Little Tynning Maslen Lane, Box Hill, Corsham Proposed Alterations

title	
Proposed Elevations	
scale	
1:100 @ A1	
Drawing No.	
Revision:	
2024 - 01271 - 204	
B

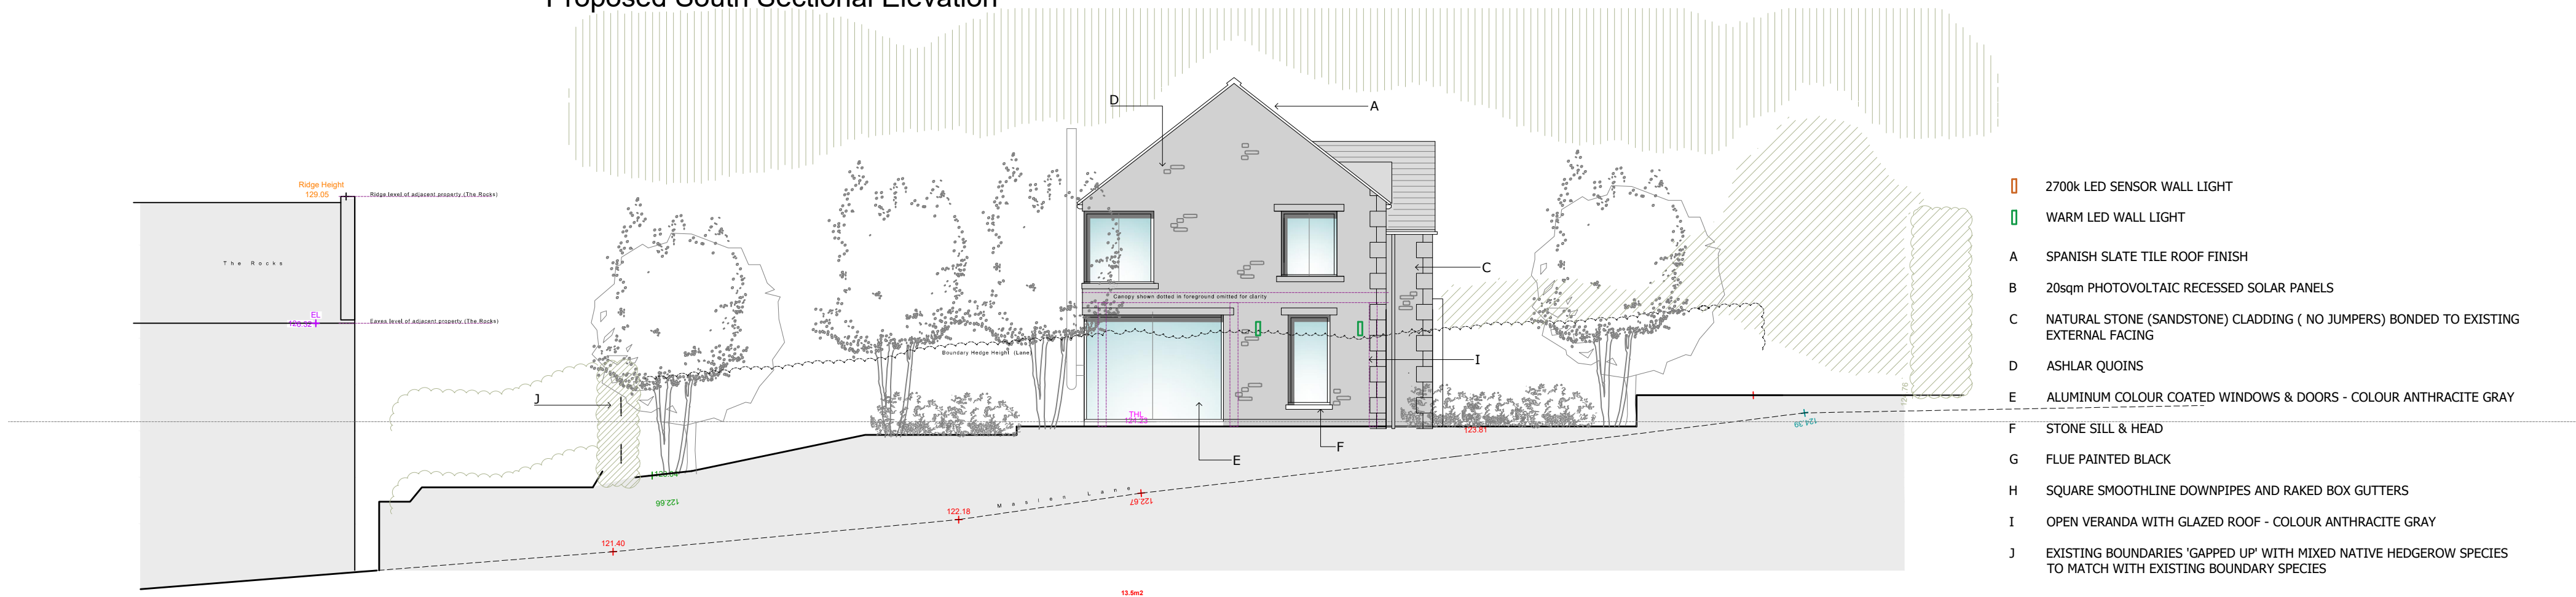
REVISION B
SEPTEMBER 2026
ELEVATIONS REVISED TO SHOW EXTERNAL FINISH TO BE NATURAL STONE THROUGHOUT AND WINDOW OPENINGS
AMENDED: FIREPLACE FLUE MOVED EXTERNALLY

REVISION A
MAY 2025
WINDOWS ON NORTH & WEST ELEVATIONS AMENDED. UTILITY DOOR ON EAST ELEVATION CHANGED TO SOLID. FIRST
FLOOR WINDOWS ON EAST ELEVATION OMITTED. LIGHTING ON FENESTRATION ADDED IN LINE WITH CONSERVATION
LIGHT SCHEME
